Subject: Issuance of Amendment No. 10 to Facility Operating License NPF-10
San Onofre Nuclear Generating Station, Unit 2

SAN ONOFRE NUCLEAR GENERATING STATION, UNIT 2

Amendment No. 10
License No. NPF-10

SAFETY EVALUATION
 AMENDMENT 10 to NPF-10
 SAN ONOFRE NUCLEAR GENERATING STATION, UNIT 2
 DOCKET NO. 50-361

FIGURE 3.7-1

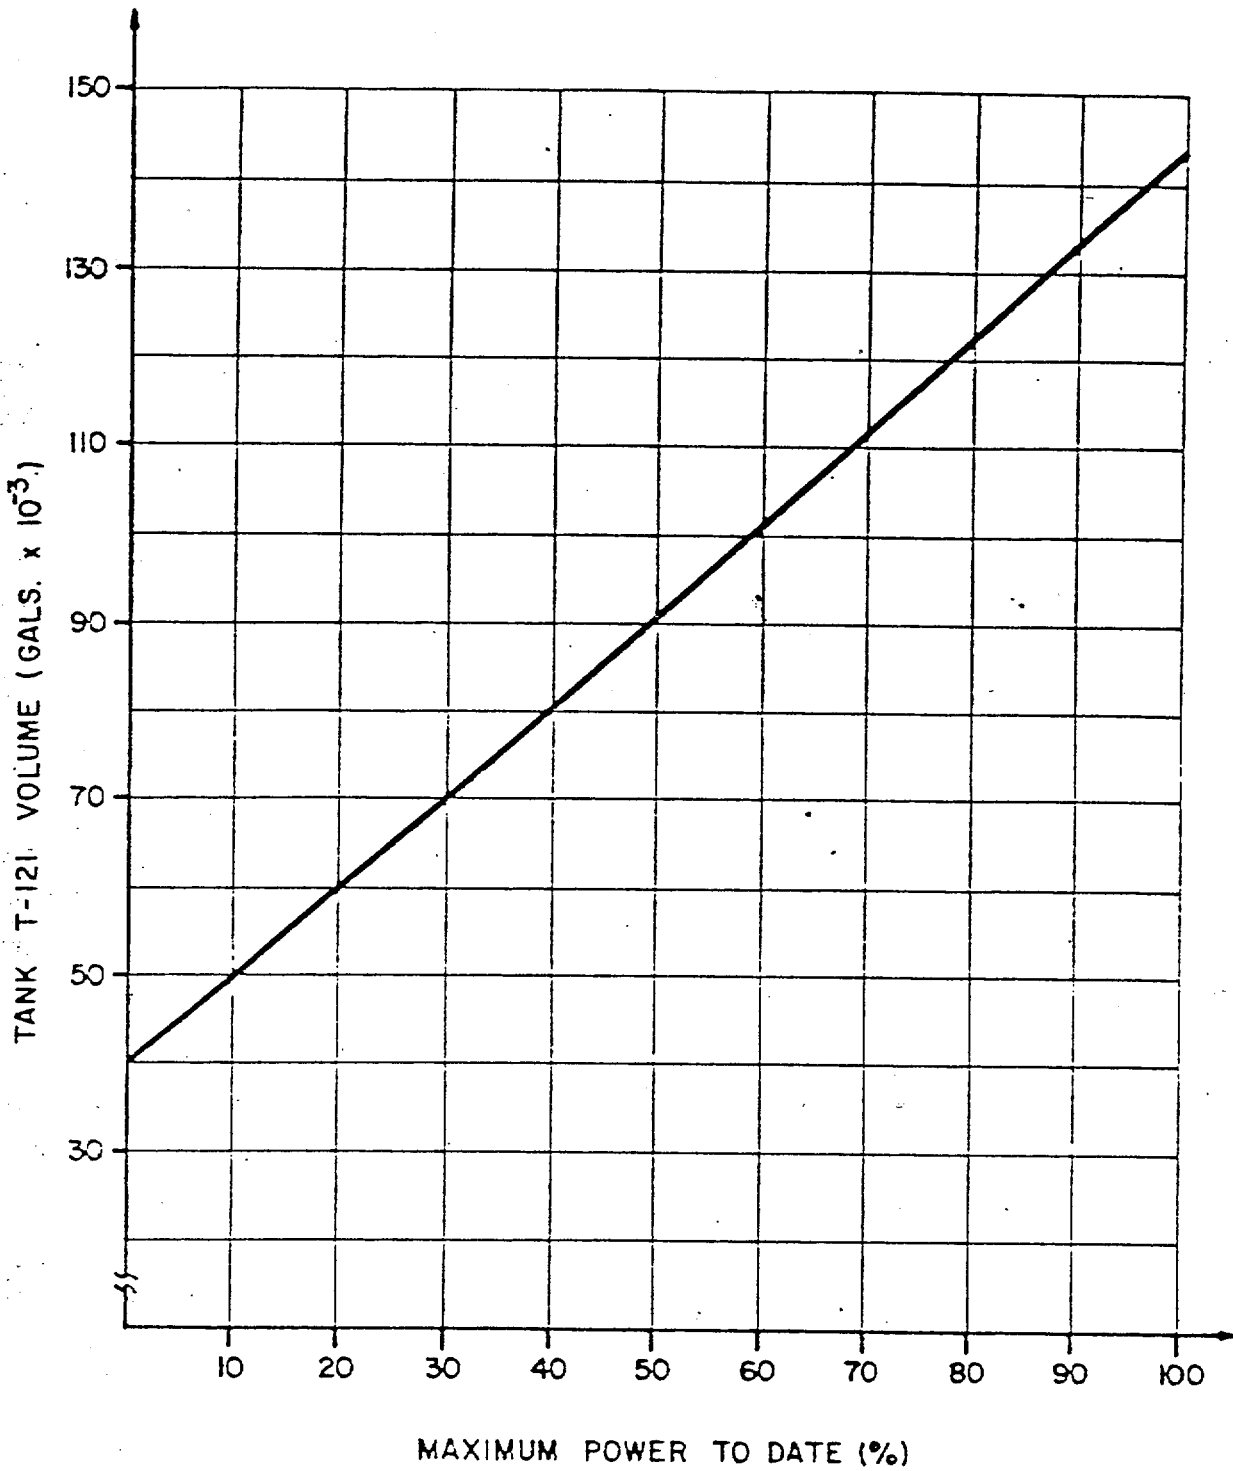
3.7.1.3 The condensate storage tanks (CSTs) shall be OPERABLE with a contained volume of at least 144,000* gallons in T-121 and 280,000 gallons in T-120.

*Prior to first achieving 100% power, the minimum volume required to be contained in T-121 is that shown on Figure 3.7-1 corresponding to the maximum power level achieved to date.

MINIMUM REQUIRED FEEDWATER INVENTORY FOR TANK T-121 FOR MAXIMUM POWER ACHIEVED TO DATE

The proposed change will ensure an adequate feedwater inventory in T-121 for 2 hours at hot standby followed by plant cooldown to 400°F, for the maximum decay heat which could be present at the time. The minimum inventories to be maintained in tank T-121 are equal to the sum of the feedwater required for decay heat removal from standard fission product decay energies for various plant power levels and the feedwater required for cooldown to shutdown cooling entry conditions. For conservatism, a +2% uncertainty for core thermal power, a +10% uncertainty in decay heat and a +20% uncertainty for the minimum inventory required at 0% power were assumed.
